Request of Class II Permissive Change

Company name: Anker Innovations Limited
FCC ID: 2AOKB-T8520
FCC Part 15 Certification

This is to request a Class II Permissive Change for FCC ID: **2AOKB-T8520** originally granted on 08/05/2020

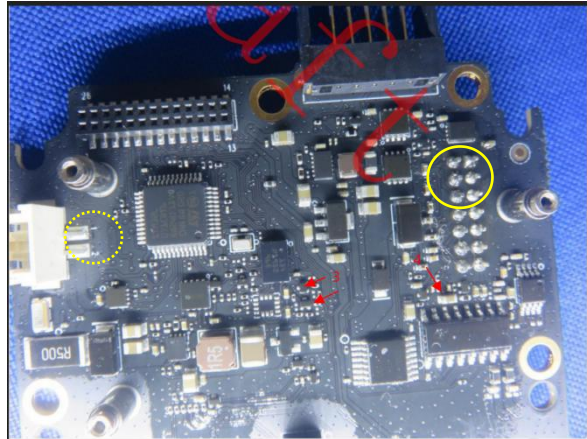
- (1) Changing the main board Model T8520-MAIN-V0.5 TO T8520-MAIN-V0.6
- (2) Changing a few parts of the main board. as follows:

No.	Name	Original	New
1	U586	G3, encryption chip , UDFN-8	Delete
2	PCB	T8520-MAIN-V0.5	T8520-MAIN-V0.6
3	Q27、Q28	None	NMOS/1V/1600m Ω /0.51A/360mW/72ns/SOT-723/1.2*1.2 *0.5mm/2kV/1, WNM2030-3/TR
4	C847	None	ceramic capacitor 10uF, 0603, X5R, 10V , ±20%

The changes are not related with the other RF parameters, only "SPURIOUS EMISSIONS" of T8520 were retested, other data were referred to the original report.
